MACK'S WAY SUBDIVISION

Engineering Comments: FINAL PLAT COMMENTS (should be addressed prior to submitting the FINAL PLAT for review and/or signature by the City Engineer):

APPLICATION NUMBER 5 DATE August 1, 2019

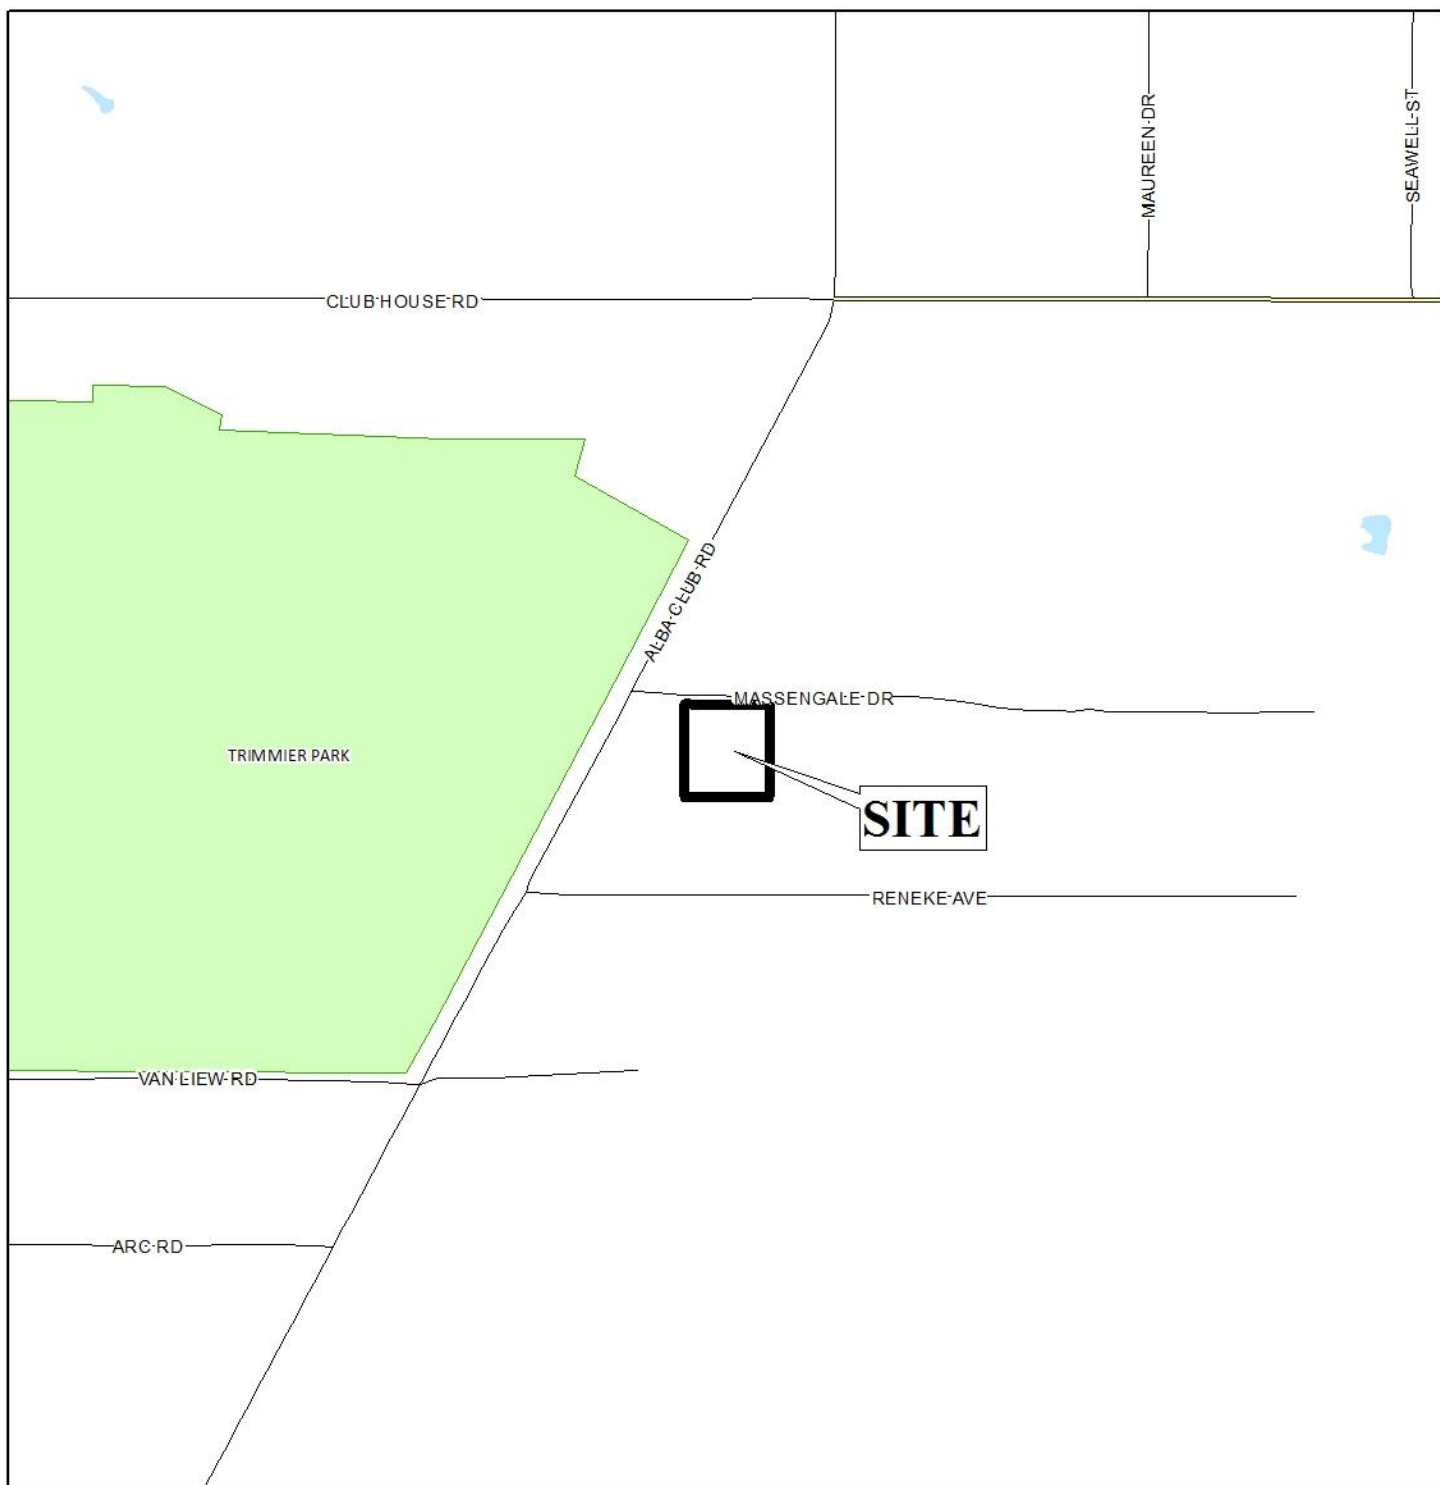
Both sites have adequate frontage along Massengale Drive, a minor closed-end street and which has an adequate 50' wide right-of-way. Per Traffic Engineering comments, driveway number, size, location and design to be approved by Traffic Engineering and conform to AASHTO standards.

As on the preliminary plat, the lot size label should be retained in both square feet and acres on the Final Plat, or a table should be furnished on the Final Plat providing the same information. No easements are indicated on the preliminary plat. Any utility easements should be retained on the Final Plat and a note should be placed on the Final Plat stating that no structure may be placed or constructed within any easement. The plat illustrates a 25' minimum building setback for both lots, which should be retained on the Final Plat.

Based on the preceding, this application is recommended for Tentative Approval, subject to the following conditions:

- 1) retention of the 25' minimum building setback line along Massengale Drive;
- 2) retention of the lot size in both square feet and acres, or the furnishing of a table on the Final Plat providing the same information, adjusted for dedication;

- 3) placement of a note on the Final Plat stating that no structure may be constructed or placed within any easement (if applicable);
- 4) compliance with the Engineering comments: *[FINAL PLAT COMMENTS (should be addressed prior to submitting the FINAL PLAT for review and/or signature by the City Engineer): A. Provide all of the required information on the SUBDIVISION PLAT (i.e. signature blocks, signatures, certification statements, written legal description, required notes, legend, scale, bearings and distances) that is required by the current Alabama State Board of Licensure for Professional Engineers and Land Surveyors. B. Provide and label the monument set or found at each subdivision corner. C. Provide the Surveyor's, Owner's (notarized), Planning Commission, and Traffic Engineering signatures. D. Add a note to the SUBDIVISION PLAT stating that a Land Disturbance permit will be required for any land disturbing activity in accordance with Mobile City Code, Chapter 17, Storm Water Management and Flood Control); the City of Mobile, Alabama Flood Plain Management Plan (1984); and, the Rules For Erosion and Sedimentation Control and Storm Water Runoff Control. E. Add a note to the Plat stating that the approval of all applicable federal, state, and local agencies (including all storm water runoff, wetland and floodplain requirements) will be required prior to the issuance of a Land Disturbance permit. F. Add a note that sidewalk is required to be constructed, and/or repaired, along the frontage of each lot, or parcel, at time of new development or construction, unless a sidewalk waiver is approved. G. Add a note to the plat stating that all proposed detention facilities, common areas, and wetlands shall be the responsibility of the Property Owner(s), and not the responsibility of the City of Mobile. H. Add a note to the plat stating that all easements shall remain in effect until vacated through the proper Vacation process. I. Provide a copy of the FINAL SUBDIVISION PLAT to the Engineering Dept. for review. No signatures are required on this drawing. J. After addressing all of the FINAL SUBDIVISION PLAT review comments by the Engineering Dept. provide the red-line markup, the ORIGINAL (with all other signatures) and one (1) copy of the revised original (signatures not required) of the revised Final Plat to the Engineering Department.];*

- 5) placement of a note on the Final Plat stating the Traffic Engineering comments: (Driveway number, size, location and design to be approved by Traffic Engineering and conform to AASHTO standards.);
